Statement No. 757

**STATEMENT THAT A PROPOSAL MAY BE IMPLEMENTED
(PURSUANT TO THE PROVISIONS OF THE
ENVIRONMENTAL PROTECTION ACT 1986)**

**PLUTO LIQUIFIED NATURAL GAS DEVELOPMENT (SITE B OPTION)
BURRUP PENINSULA, SHIRE OF ROEBOURNE**

Figure 6: Additional areas (additional 3.03 hectares in total) included in the approved land disturbance footprint for the construction of Pluto Train 2.

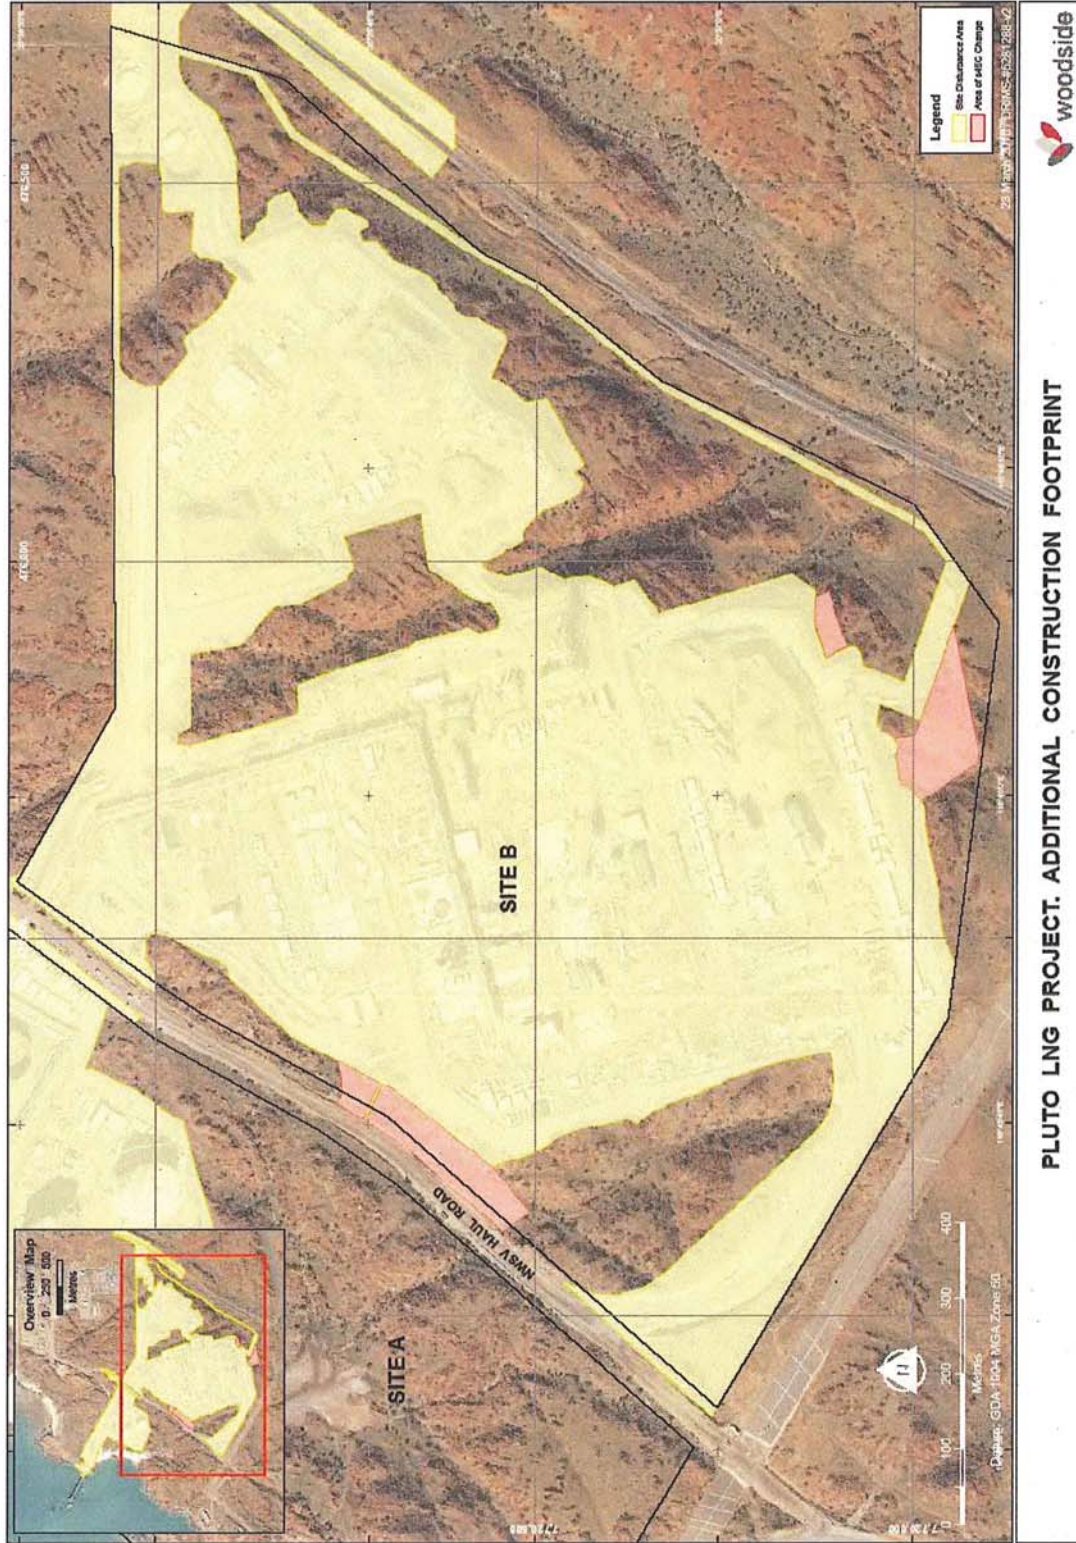
Change: To increase the land disturbance footprint of the proposal by 3.03 hectares.

Figure 7: Pluto LNG Site – MS 757 Approved Disturbance Footprint.

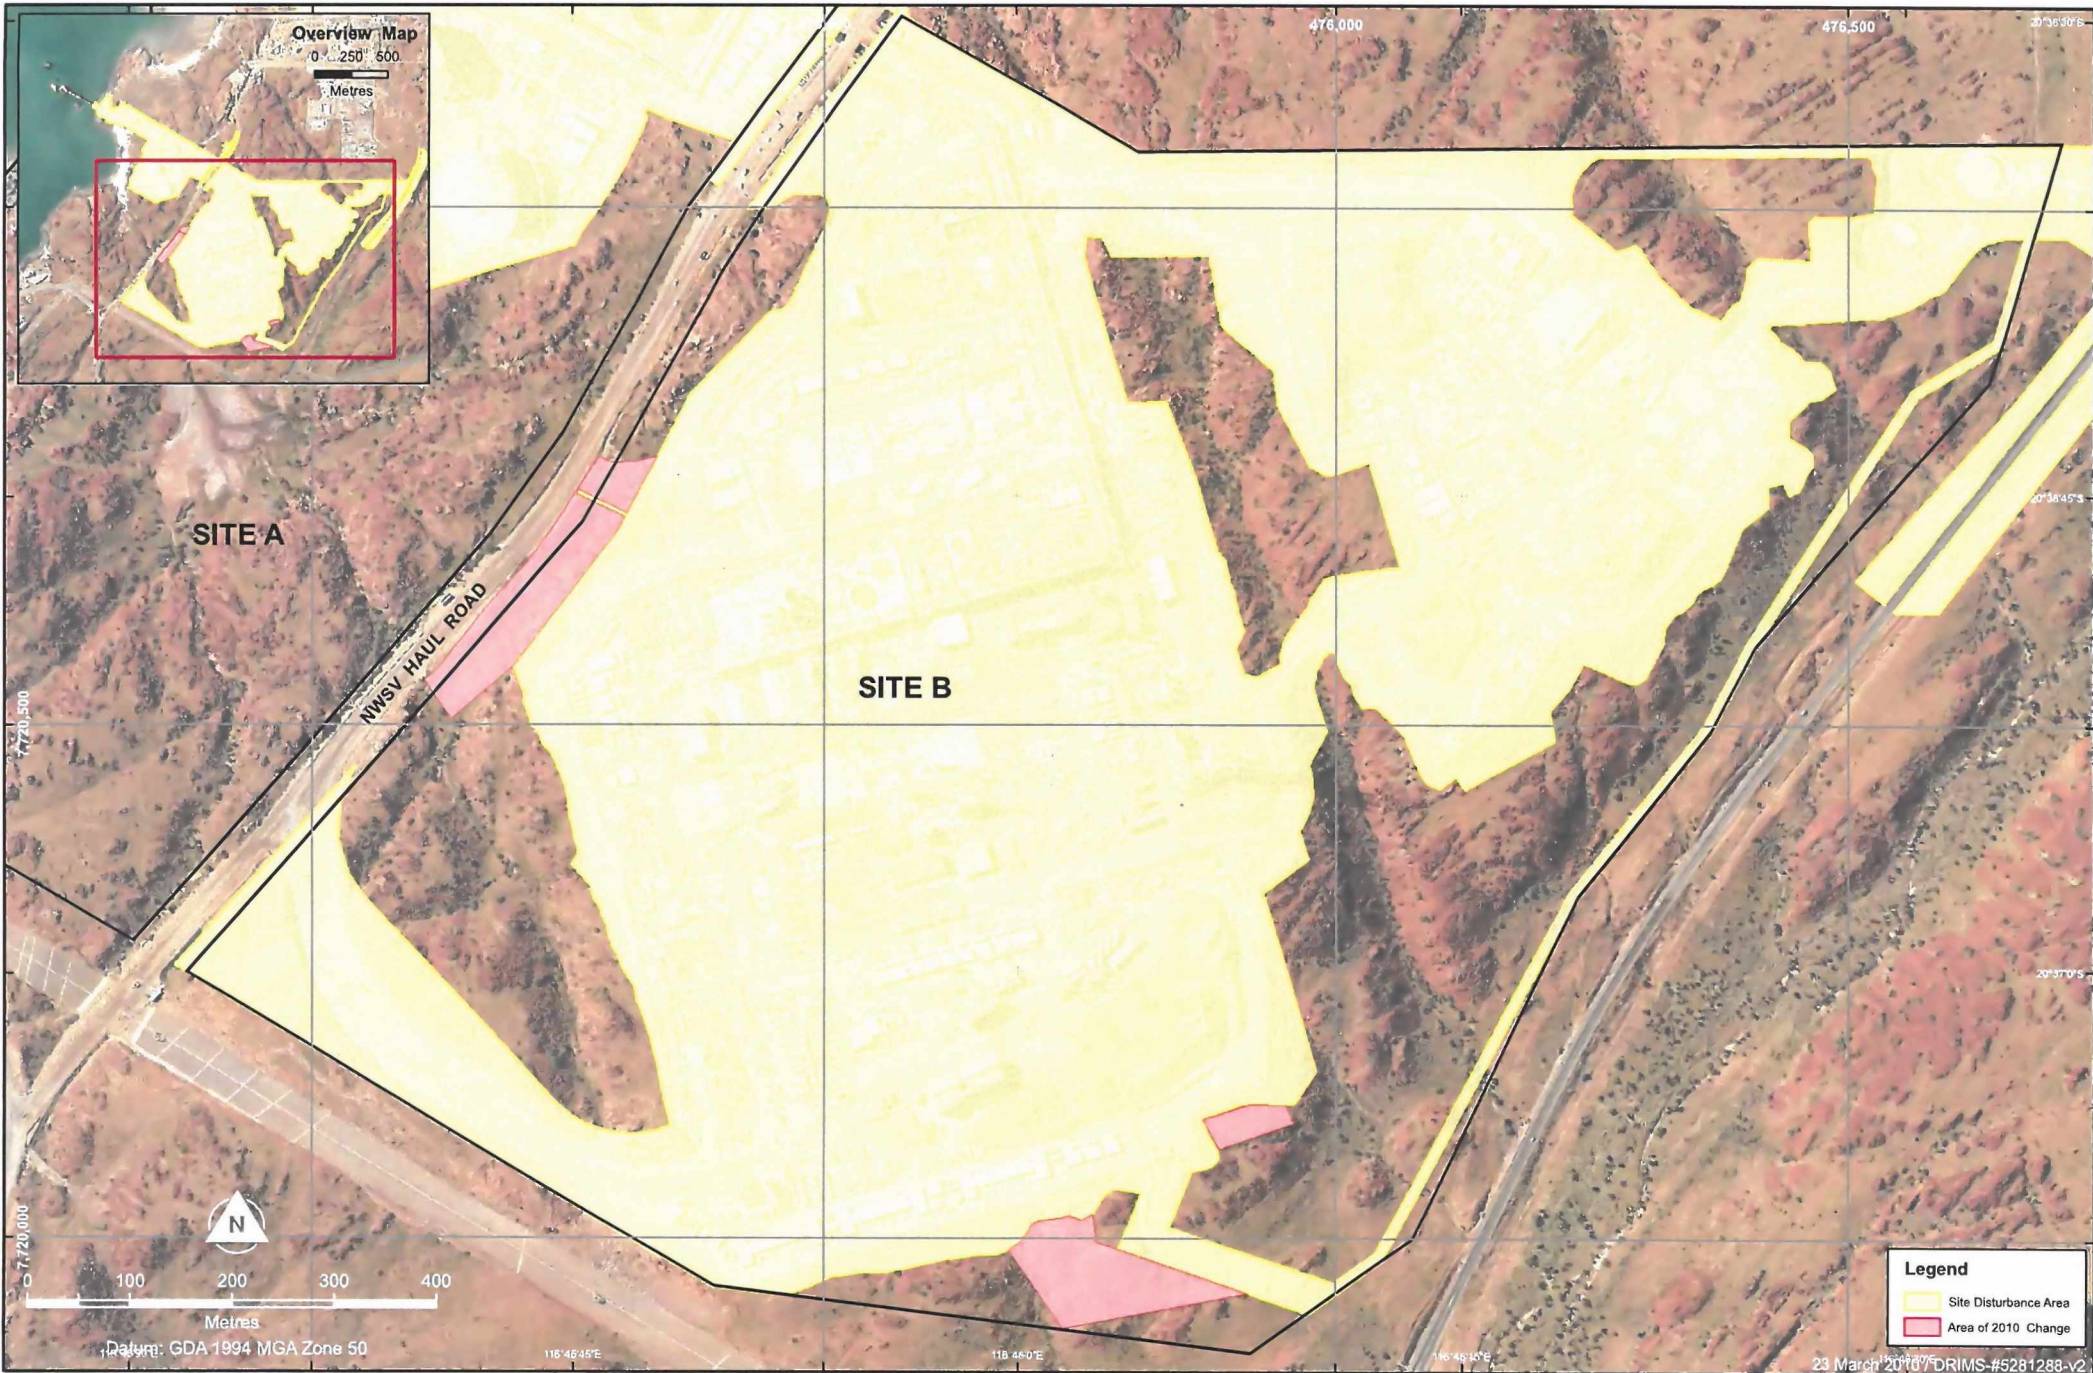
- Deletion of the described gas field from the Proposal preamble, to clarify that gas from other fields can be processed at Pluto LNG (as per the Public Environmental Review);
- Deletion of the described gas turbine types used to drive the liquefaction compressors and for power generation from Schedule 1, to allow for greater flexibility in turbine design;
- Inclusion of gas export via shipping, trucking or piping to Schedule 1, to reflect the existence of the Pluto LNG trucking facility and proposed Pluto-North West Shelf Interconnector.
- Deletion of the described gas field Pluto North West Shelf from the Proposal Schedule 1 to gas fields.
